# **DEVELOPMENT APPLICATION ASSESSMENT REPORT**

Application Number:	DA2020/0461		
Responsible Officer:	Jordan Davies		
Land to be developed (Address):	Lot 10 DP 246984, 133 Owen Stanley Avenue ALLAMBIE HEIGHTS NSW 2100		
Proposed Development:	Alterations and additions to a dwelling house		
Zoning:	Warringah LEP2011 - Land zoned R2 Low Density Residential		
Development Permissible:	Yes		
Existing Use Rights:	No		
Consent Authority:	Northern Beaches Council		
Land and Environment Court Action:	No		
Owner:	Conal O'Kelly Katrina Michelle O'Kelly		
Applicant:	Conal O'Kelly		
Application Lodged:	11/05/2020		
Integrated Development:	No		
Designated Development:	No		
State Reporting Category:	Residential - Alterations and additions		
Notified:	25/05/2020 to 08/06/2020		
Advertised:	Not Advertised		
Submissions Received:	0		
Clause 4.6 Variation:	Nil		
Recommendation:	Approval		
-

## Description of non-compaliance

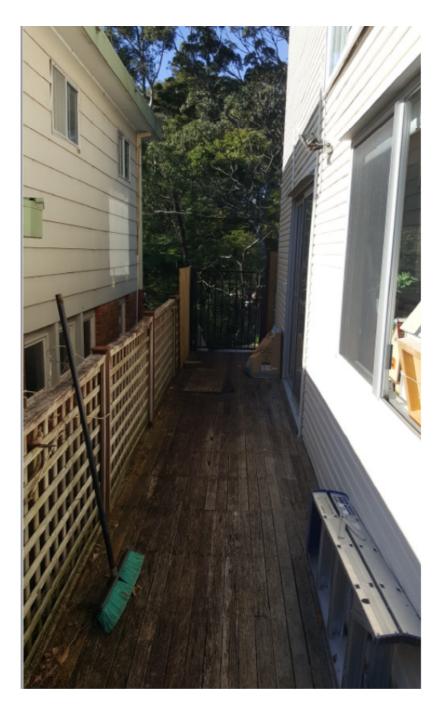
The DCP requires that a side setback of 0.9m is provided. The proposed dwelling and new works are compliant with the side setback with the exception of the deck along the northern side boundary. The deck has a zero setback to the northern boundary.

It is noted at present there is a deck/pathway in this location and the proposed development involves replacement of the existing timber deck with tiled paving to match the new covered entertaining area and provide easy access around the northern side of the dwelling.

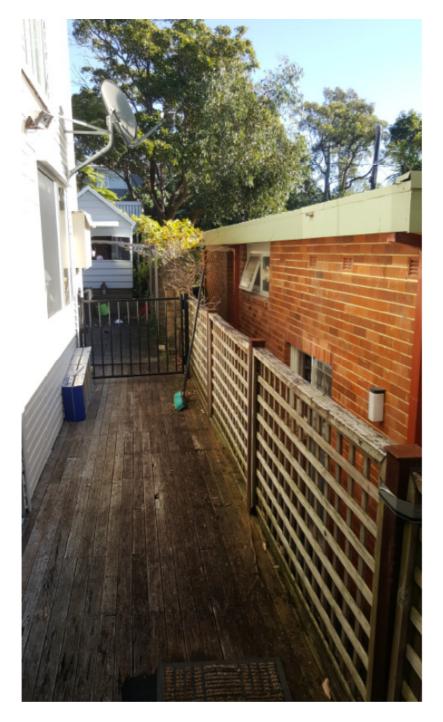
It is unknown if development consent has been granted for the existing deck and based on the visual appearance of the deck it appears to have been there for a number of years. The proposal seeks to replace this area 'like for like'. The following site photographs were taken of the existing deck:

Given the deck is located in proximity to the boundary, a boundary identification survey will be required as a condition of development consent to ensure all works are within the property boundary.

<u>Comment:</u> As seen in the above figure, there are existing sliding doors leading onto the deck, therefore, it is reasonable to have some form of landing to service the existing sliding doors providing access to the side of the dwelling. The windows on the adjoining property to the north are all obscure glazed and based on the site inspection service bathrooms and storage rooms on the lower floor. There are no living room windows, kitchen windows or windows that provide direct visibility to bedrooms on the adjoining elevation.
